SURREBUTTAL TESTIMONY

BECKER v. AQUA MISSOURI, INC.

RE: Lake Carmel Subdivision
Wastewater Treatment Improvements
Response to PSC Testimony

**Lake Carmel Lagoon Volume Confirmation
For
Jason Becker**

CELL #1 Area = 0.726 Acres
 Average Depth = 3.147 feet
 Volume = 2.285 Acre-Feet = 744,518 Gallons

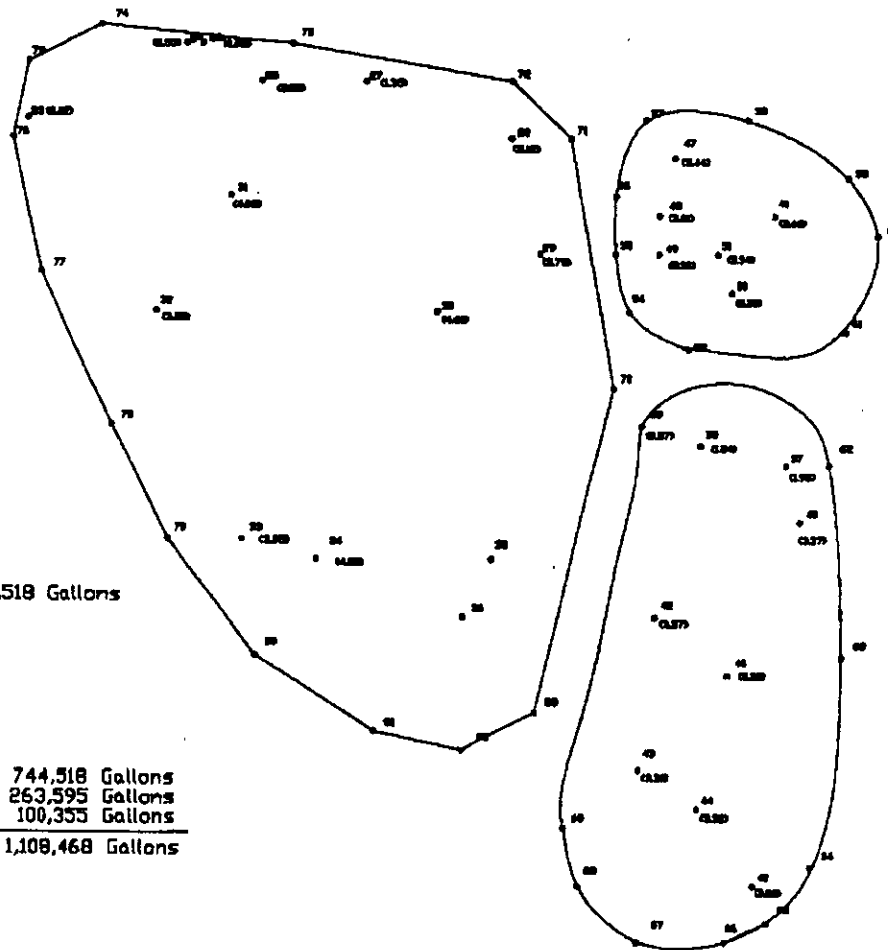
The calculated volume, based on confirmed areas and average depths, is 1,108,468 gallons at present. This translates to a maximum flow at 120 days detention time of 9,237 gallons, which is below the permitted figure of 12,600 gallons per day. A total of 1.24 Acre-Feet or 404,027 Gallons in additional volume is needed to provide for 12,600 gpd.

Summary: Verified cell volumes are low, probably due to sludge accumulation and siltation. Modification of the cells to raise level and provide proper volume and freeboard can be done by adjusting the outlet pipe elevations and raising the berm elevations. Placement of new compacted clay fill should be done by first stripping the vegetation from the berm surfaces and then laying up new compacted clay fill in lifts not exceeding 6 inches.

The surface area of the system totals 1.123 Acres. Addition of 1.1 feet of depth can provide the capacity needed. In order to do this, it will be necessary to modify the outlet pipes from each cell, and to raise freeboard accordingly. The length and slope of the entering line should be sufficient to allow this amount of increase.
